## **IMPORTANT RECALL INFORMATION**

August, 2004

**SUBJECT: RECALL CAMPAIGN #40715  
Draw Tite Hitch Receiver**

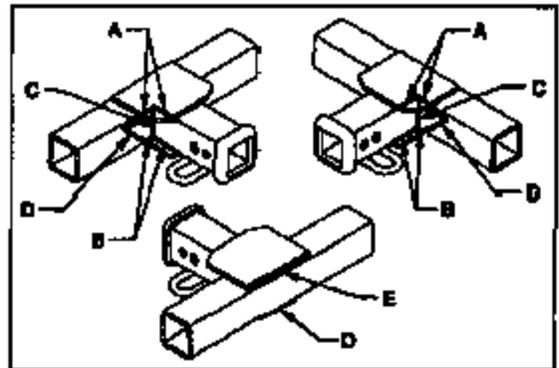
Fleetwood has learned that a small percentage of hitch receivers may have missing welds. All affected motor homes will need to have the hitch receiver welds inspected. Hitch receivers with missing welds must be replaced.

1. Park the motor home on a flat surface. Put the transmission into Park. Set the parking brake. Turn off the ignition and remove the key from the ignition switch.
2. Use the diagram in the Bulletin for reference.
3. Inspect the hitch receiver for welds at all identified locations in the diagram.

- Location "A", the underside of the top reinforcement plate.
- Location "B", the top side of the bottom reinforcement plate.
- Location "C", the vertical corner between the receiver box and the cross member tube.
- Location "D", the edges of the bottom reinforcement plate and the cross member tube (three sides).
- Location "E", the forward facing edge of the top reinforcement plate at the corner of the cross member tube (forward edge only).

4. If any welds are missing from the identified locations, the hitch receiver will need to be replaced.
5. Some hitch receivers may have additional welds, which are not cause for rejection.
6. If the hitch receiver contains all of the identified welds, the inspection is complete and no further action is required on the motor home.

9. Install the new hitch receiver using new 1/2"-20 X 2" Grade 5 bolts, 1/2" Grade 5 flat washers, 1/2" Grade 5 lock washers, and 1/2"-20 Grade 5 nuts. The number of replacement bolts must equal the same number of fasteners originally used to mount the hitch receiver.

10. Torque the nuts to 85 ft./lbs. +/- 5 ft./lbs.
11. Reattach the hitch receiver electrical plug and connect the wires to the terminals.
12. Reassemble the hitch receiver electrical plug into the mounting bracket.
